### 145.2.8.5.1 PSE ~~PI~~ pair-to-pair effective resistance and current unbalance

### 145.3.8.10 PD pair-to-pair current unbalance

## Annex 145A

Figure 145–22 — PSE current unbalance verification circuit

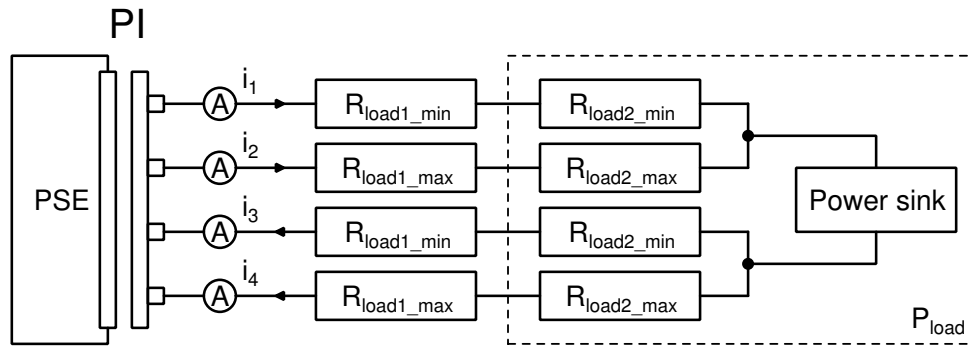
Figure 145–22 is a test fixture that is used in the PSE unbalance requirement. Because it was originally drawn for an Annex, it is too elaborate and shows parameters beyond the PI. It also contains a PD model, which is non-relevant for the PSE unbalance specification.

The equivalent Figure on the PD side is much better (Figure 145–31). Figure 145–22 is redrawn in the style of 145–31 and the PD specific details are abstracted away. The PD specification uses  $R_{source\_min}$  and  $R_{source\_max}$  as the test fixture parameters, for the PSE side we introduce  $R_{load1}$  and  $R_{load2}$ .

Replace Figure 145–22 as follows:

Replace the evaluation method on page 161 lines 22 to 32 by the following:

The evaluation method is as follows:

- Use  $R_{load\_min}$  and  $R_{load\_max}$  from Equation (145–16) and Equation (145–17) for low channel resistance conditions.
- Adjust the power sink such that  $P_{load}$  (the power consumed by the  $R_{load2}$  resistances and the power sink) equals  $P_{Class\_PD}$  for the given Class
- Verify that  $i_1$ ,  $i_2$ ,  $i_3$ , and  $i_4$  are lower than  $I_{Con-2P-usb}$ , as defined in Table 145–16.
- Exchange  $R_{load\_max}$  and  $R_{load\_min}$ . Repeat steps b) and c).
- Repeat steps b) through d) for  $R_{load\_min}$  and  $R_{load\_max}$  from Equation (145–16) and Equation (145–17) for high channel resistance conditions.

Figure 145–31 — PD current unbalance verification circuit

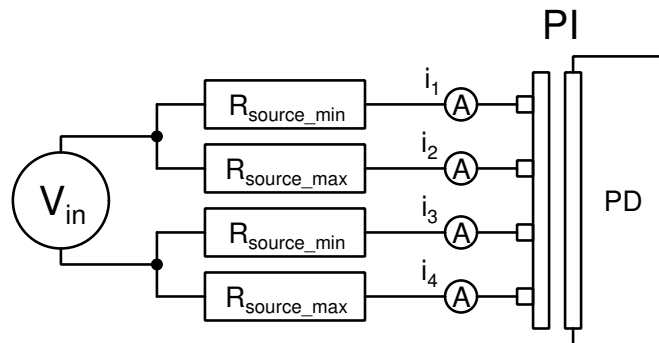
Replace Figure 145–31 as follows:

Figure 145A-0a — PD current unbalance verification circuit

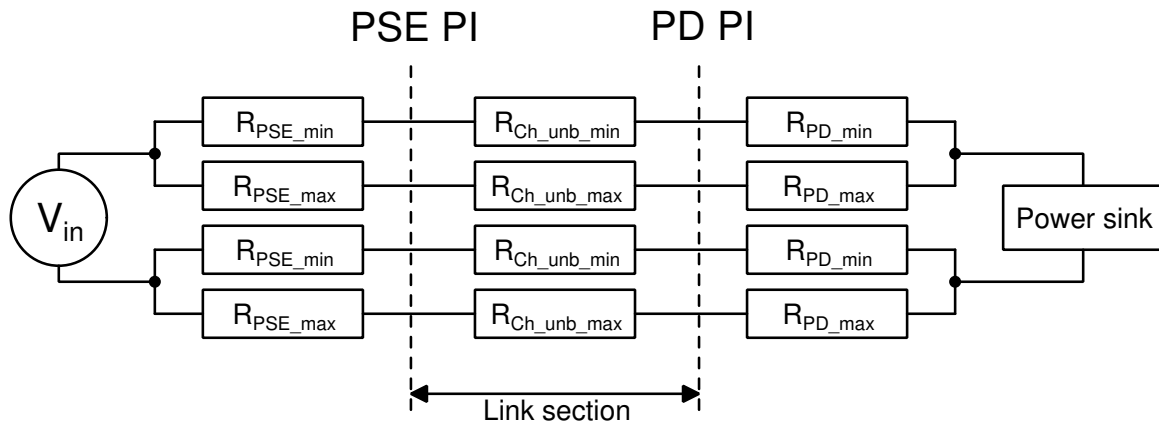
We still need a Figure that shows  $R_{PSE\_min}$  and  $R_{PSE\_max}$  as these parameters are referred to in the text. We can replace Figure 145A–1 with something that shows all.

Insert new subclause before 145A.2 as follows:

Pair-to-pair current unbalance is caused by unequal resistances in a parallel current path. The PSE, the PD, and the link section connecting those independently contribute to unbalance. A system model for the worst-case instance of this is shown in Figure 145A-0a.

$R_{PSE\_min}$  or  $R_{PSE\_max}$  common mode effective resistance is the resistance of the two internal conductors (including the internal components on each conductor) in a powered pair of the same polarity connected in parallel.

$R_{Ch\_unb\_min}$  and  $R_{Ch\_unb\_max}$  are respectively the minimum and maximum common mode link section resistances in the powered pairs of the same polarity from the PSE PI to the PD PI per the model described in Figure 145A-1.

The sum of  $R_{Ch\_unb\_min}$  from the positive pairs and  $R_{Ch\_unb\_max}$  from the negative pairs is  $R_{Chan-2P}$  as described in Figure 145-22 and as defined by the link section pair-to-pair resistance unbalance requirement for 4-pair operation in 145A.3.

$R_{PD\_min}$  and  $R_{PD\_max}$  are respectively the minimum and maximum common mode effective PD PI resistances. They account for the effective resistance of the resistive elements, combined with the PD pair-to-pair voltage difference and the effect of system end-to-end pair-to-pair unbalance.
